Access Compliance Report

Public Rights-of-Way

(Curb Ramps)

Intersection ID: 27738	Main Street: JAMES JACK LN	Cross Street: VILLALONGA LN	Location: W
ADA ID: 3E71342235D9	Ramp Type: PerpDiag	Initial Pass/Fail: Fail	Overall Compliance: No
Codes/Mitigation Info/Possible Solution			Severity Score: 17.5
			Field Measurements/Component Compliance

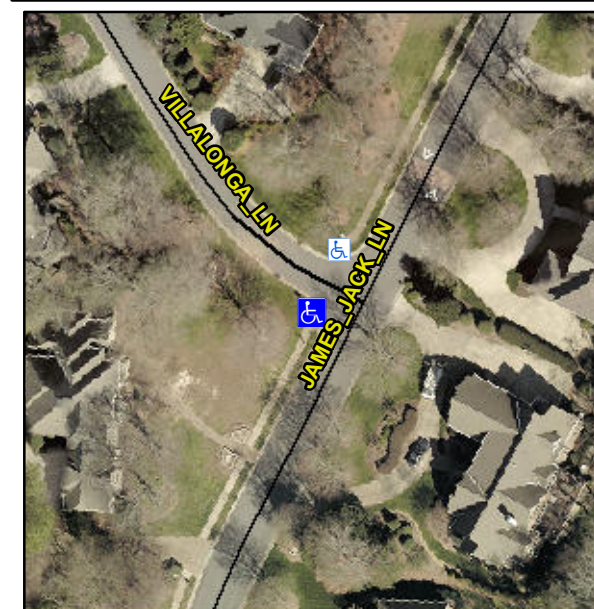
R304.5.1

Compliance	Description	Data	Compliance	Description	Data
N/A	Ramp Length (in)	50.0	Yes	Ramp Slope (%)	7.5
No	Ramp Width (in)	35.0	Yes	Ramp XSlope (%)	1.1
N/A	Flare Type LT	N/A	N/A	Flare Type RT	N/A
N/A	Flare Slope LT (%)	N/A	N/A	Flare Slope RT (%)	N/A
N/A	Flare Traversable LT?	N/A	N/A	Flare Traversable RT?	N/A
N/A	Landing Length (in)	N/A	N/A	DWS Provided?	N/A
N/A	Landing Width (in)	N/A	N/A	DWS Contrast?	N/A
N/A	Landing Slope (%)	N/A	N/A	DWS Length (in)	N/A
N/A	Landing X Slope (%)	N/A	N/A	DWS Full Width?	N/A
N/A	Landing Curb? (Y/N)	N/A	N/A	DWS Offset (in)	N/A
N/A	Shared Landing?	N/A			
N/A	Gutter Ponding?	N/A	N/A	Gutter Slope (%)	N/A
N/A	Gutter Lip Ht (in)	N/A	N/A	Gutter X Slope (%)	N/A
N/A	Painted X Walk1?	No	N/A	Painted X Walk2?	No
	X Walk 1 Direction	To SE		X Walk 2 Direction	To NE
N/A	X Walk 1 Width (in)	N/A	N/A	X Walk 2 Width (in)	N/A
	X Walk 1 Slope (%)	1.5		X Walk 2 Slope (%)	2.0
	X Walk 1 X Slope (%)	3.8		X Walk 2 X Slope (%)	2.9

Remove & Replace Curb Ramp With Two New Directional Ramps or Equivalent.
